CMD 25-H12.45

**Written Submission from the
Ya'thi Néné Lands and Resources
Office**

License application to prepare a site for
and construct its Rook I uranium mine and
mill project

YA'THI NÉNÉ LANDS AND RESOURCES INTERVENTION

FIGURE 1: MAP SHOWING EXTENT OF MINERAL DISPOSITIONS AND ACTIVE PERMITS WITHIN NUHENÉNÉ AS OF SUMMER 2025

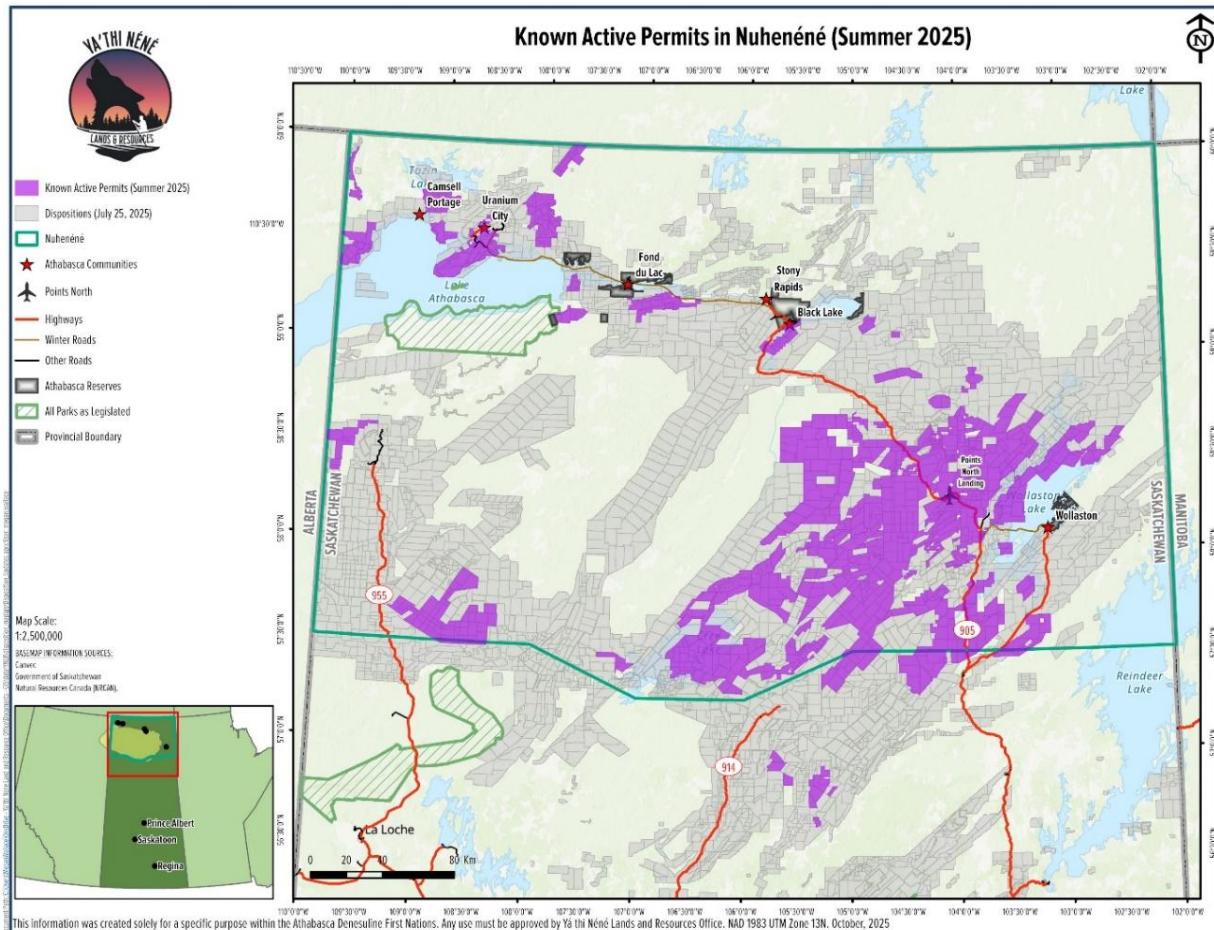
We retain our concern regarding cumulative effects, despite the acceptance of such effects on caribou by NexGen. The total extent of human disturbance on the landscape was not sufficiently accounted for in the EIS. Our own estimate shows that the total amount of known linear disturbance within Nuhenéné is more than 20,400 km and growing. Furthermore, looking into the future, the total number of current mineral claims and exploration activity is also increasing rapidly (see Figure 1). Importantly, the Rook I Project is not occurring in isolation; its development has the potential to exert a compounding influence that accelerates additional mineral exploration and associated disturbance both within and beyond the local and regional study areas as defined by NexGen.

Looking forward, the cumulative terrestrial effects associated with increased exploration activity emphasize the need for improved regional land management approaches. While YNLR recognizes that broader solutions such as a provincial land management policy are beyond the scope of this hearing, interim measures could meaningfully reduce future impacts. These include clearer siting guidelines intended to minimize the creation of new linear disturbances, requirements for the submission of accurate and complete spatial data (including shapefiles) for all new and refurbished linear disturbances with associated dates and usage details, and the inclusion of enforceable mitigation and restoration requirements within surface access permits.
